ACCELERATED DISTRIBUTION DEMONSTRATION SYSTEM

SUBJECT: Part 21 rept re Foxboro Spec 200 termination modules, four Model N2AK+T & three Model N2AK+K. Defects identified in metallic termination module labels found w/clearances less than acceptable Foxboro std of 0.06 inches.

Subject: 10 CFR 21 Notification
R. E. Ginna Nuclear Power Plant
Docket No. 50-244

SUBJECT: Termination Modules used in Foxboro's SPEC 200
Product Line
Various Part Numbers (See Attachment I)

ITEM A: FOR 4-20 mA INPUT

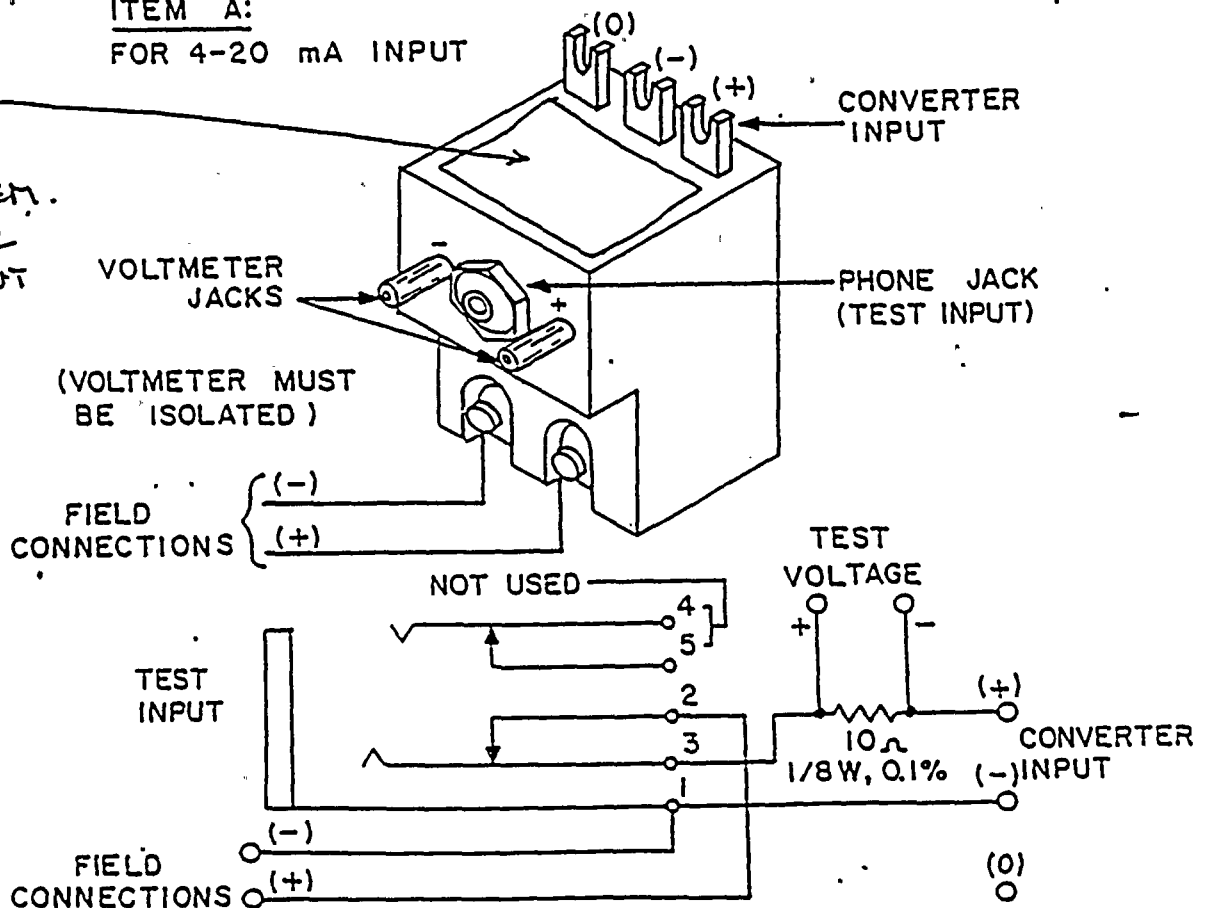
This is to inform you that one of our nuclear customers has reported a problem with Foxboro's Custom Termination Modules. The problem was described to be the metallic label shorting the signal input spade lugs which resulted in a shorted input signal. We received two units from this customer. On one unit we could duplicate the problem; on the other unit we could not duplicate the problem, although the label looked to be very close to the spade lugs (less than .060 inch, which is our standard).

LABEL
THAT
CAUSED
THE PROBLEM.
SEE PAGE 2
OF ATTACHMENT
II.

This is the first reported problem since we introduced these modules more than 18 years ago. We believe if similar modules are already installed in your system and no problems have been experienced to-date, the shorting of the label to the lugs is unlikely. However, we are recommending that you inspect the units for label proximity to the lugs. Any suspected units must be removed and tested for a short circuit between the spade lugs. If a short circuit exists, the only corrective action required is to move the label away from the lugs. Please check your spare parts inventory also.

We have instituted the use of a non-metallic label so as to avoid any future problems.

TERMINATION MODULE LABEL PLACEMENT

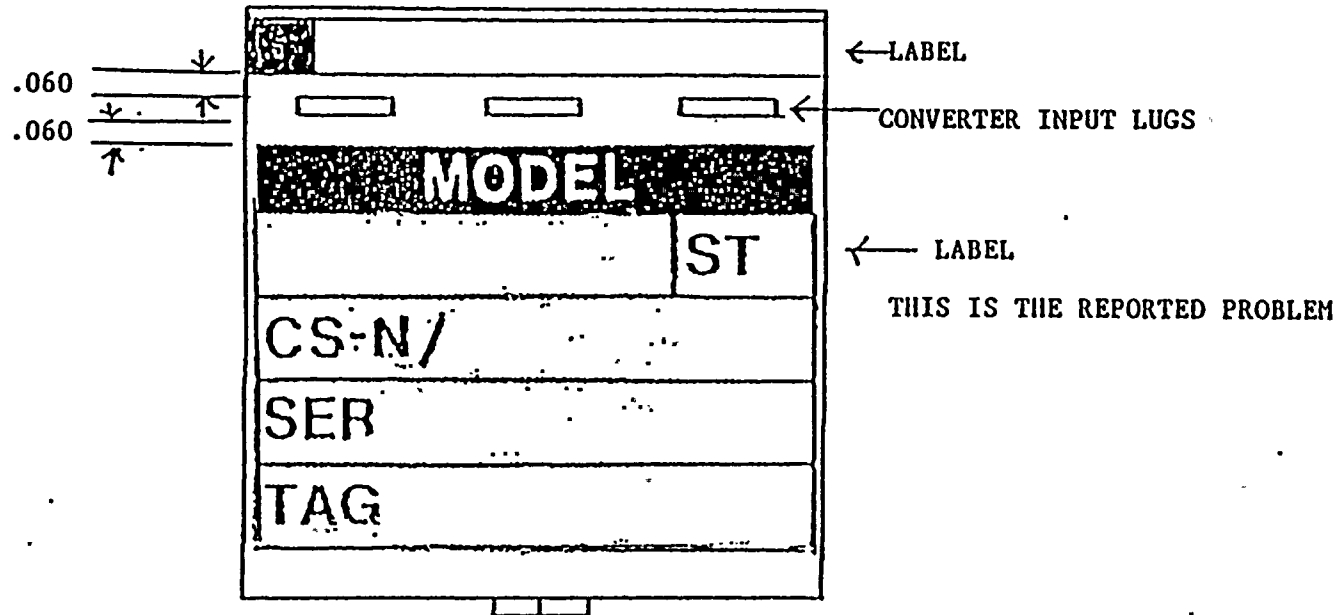
During the inspection of the in stock spare modules, the specific defects identified were the metallic termination module labels were found with clearances less than the acceptable Foxboro standard of 0.06 inches between the label and the signal input spade lugs, which could result in a shorted input signal.

The corrective action that was taken regarding this condition was per Foxboro recommendations (i.e. to move the label away from the lugs). These seven modules have been corrected. Additionally, the Quality Control Inspectors were informed of this problem so that during future receipt inspection activities, they may be identified prior to acceptance.
